City of Richmond
Planning and Development Department

Report to Committee

To: Planning Committee
From: Brian J. Jackson, MCIP
Director of Development
Date: March 23, 2011
File: RZ 09-506908
Re: Application by W.T. Leung Architects Inc. for Rezoning at 6331 and 6351 Cooney Road from Downtown Commercial (CDT1) and Low Density Townhouses (RTL1) to High Rise Apartment (ZHR8) - Brighthouse Village (City Centre)

This application was presented to the Richmond Advisory Design Panel (ADP) meeting of November 17, 2010 and was supported to move forward to Planning Committee. See **Attachment 5** for ADP comments followed by the Applicant responses.

WEST ELEVATION

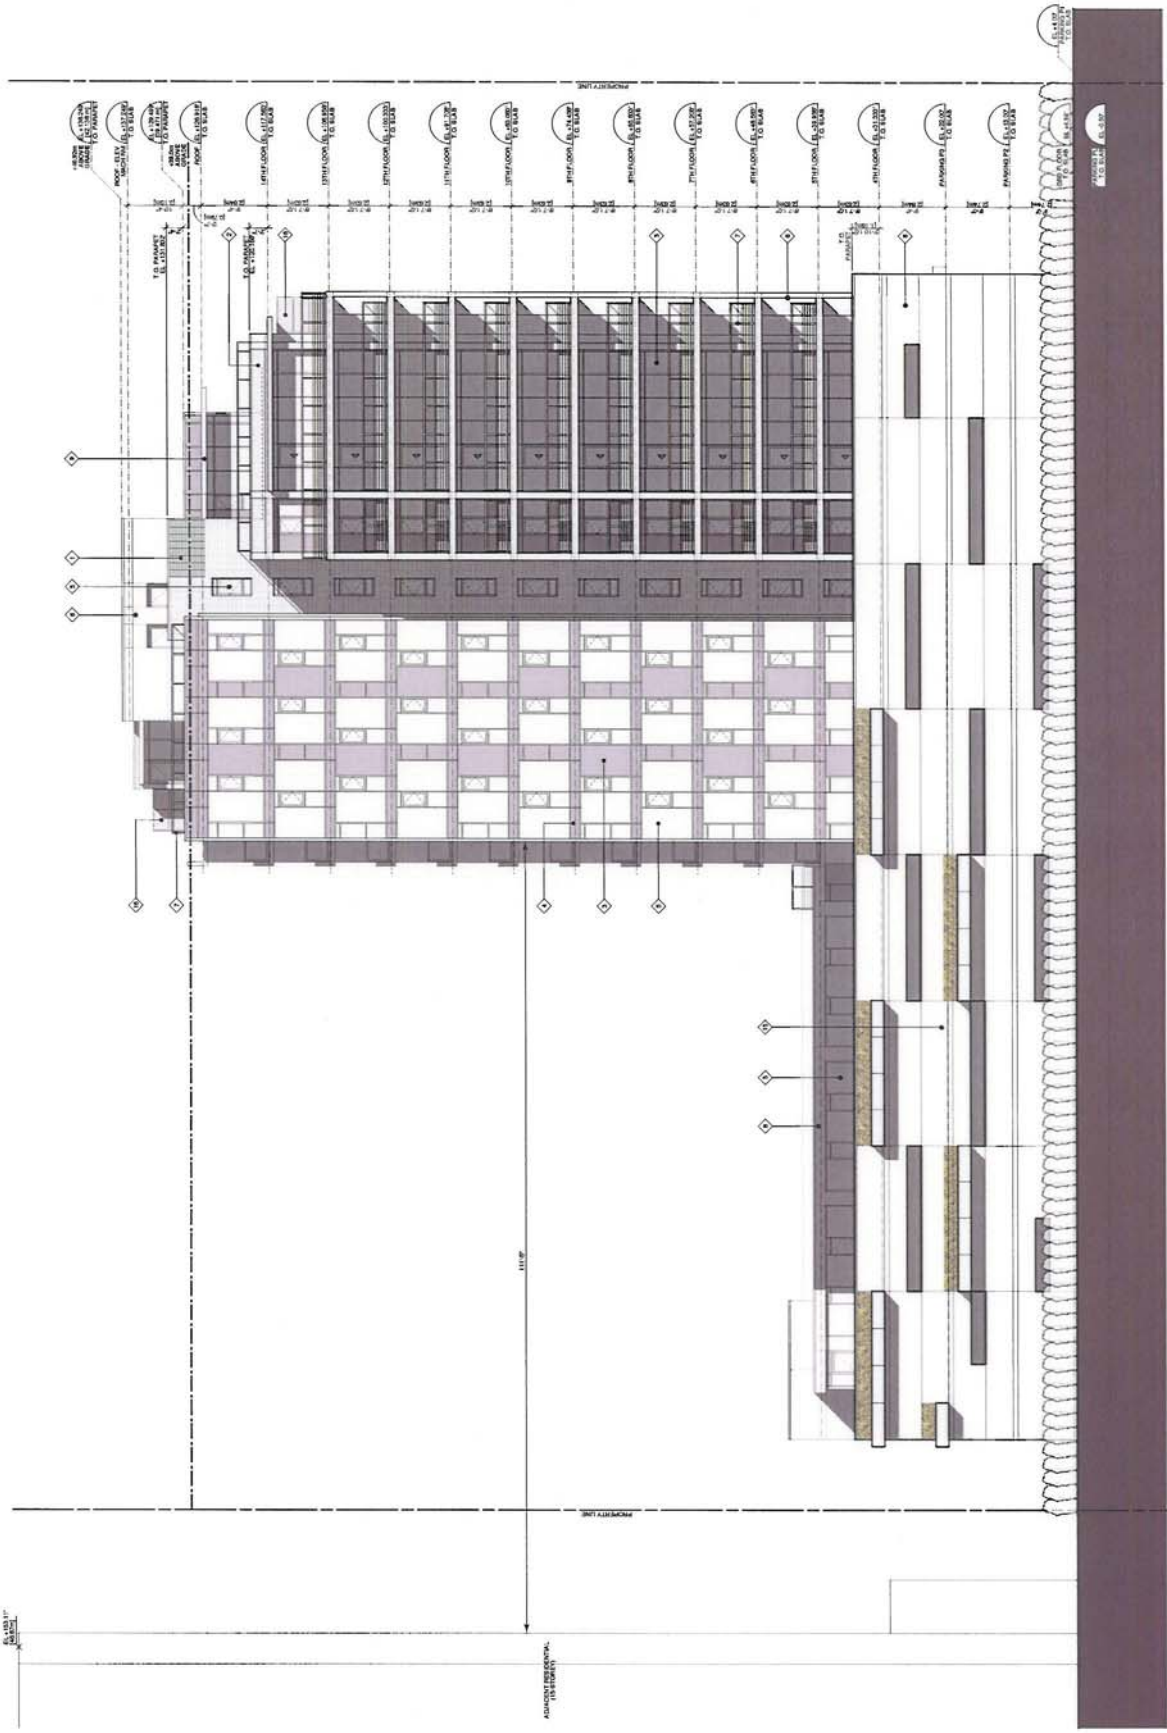
1. Design development to provide screening for rooftop mechanical equipment. ***Applicant Response: Rooftop mechanical equipment is screened by the raised brick masonry parapets between grid lines 3 and 4.***

Level 4 - Amenity Landscape Plan

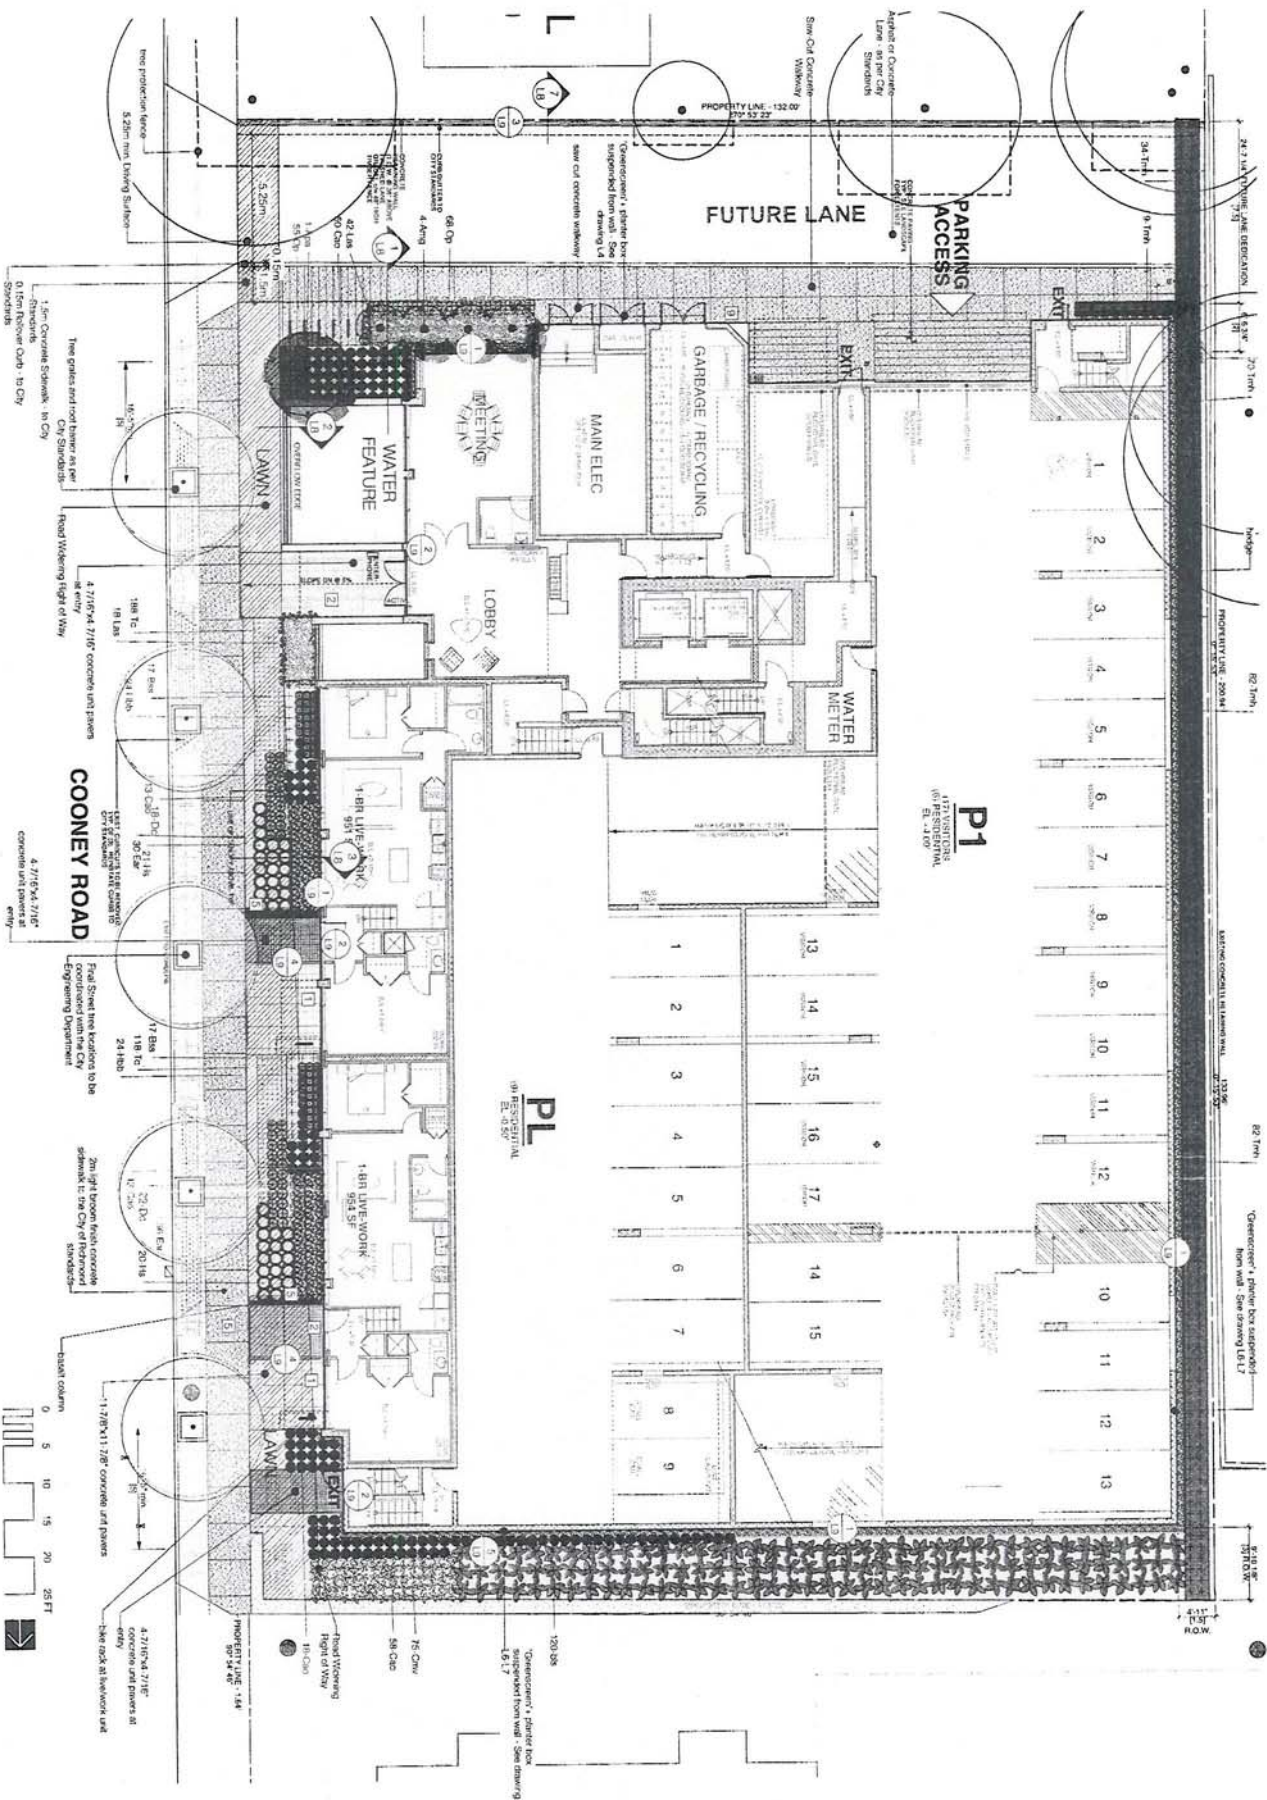
3. Consider strengthening the design of the play area surrounding the play equipment. *Applicant Response: The children's play area has been refined to provide additional detailing, denser landscape planting and creative play opportunities.*
